2007 Service Handbook

Service Bulletins

Fig 3

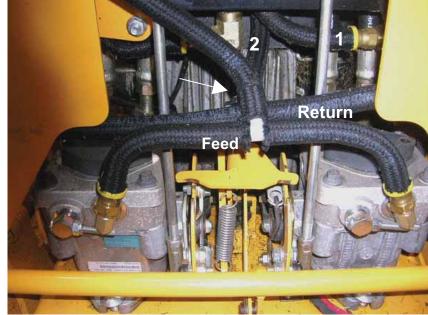
Situation: It has been determined that the hydraulic oil cooler for these

mowers is unnecessary for the hydraulic system and that it should be removed. All mower registrations must be completed

NOTE: The two photos below (Fig's 3 & 4) are using the numbers 1 & 2 to indicate which hose from Fig 3 will correspond with the hose from Fig 4.

- 6. Cut wire ties holding feed and return line together (see arrow in Fig 4)
- 7. Crimp hose at hydro tank return (Fig 4 hose 1)

NOTE: Crimping tool would be ideal, if you do not have, use care not to crush hose.
- 8. Hose 2 needs to be cut from the return line tee. Use care not to cut yourself and not to damage the tee.

9. Remove line 1 from cooler (Fig.3) and cut 5" from end **NOTE**: Some oil may spill

Bottom view of old routing configuration: Fig. 1

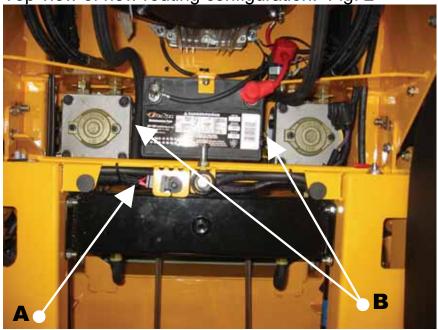
Situation: The hydraulic hose is routed below the hydraulic tank and can

come in contact with the deck belt. If this happens, the belt can

wear through the hose and cause the hose to leak

Hose routed horizontally below the hydro tank

The Fix: Re-route the hose from the hanging position to up between the

hydraulic tank and mower frame as pictured below. The hose fittings on the pump will need to be re-oriented to accommodate

Top view of new routing configuration: Fig. 2

Hose looped up between the hydro tank and the frame (A) and the pump fittings are re-oriented at an angle towards the bottom of the hydro tank to eliminate the possibility of hose binding (B)
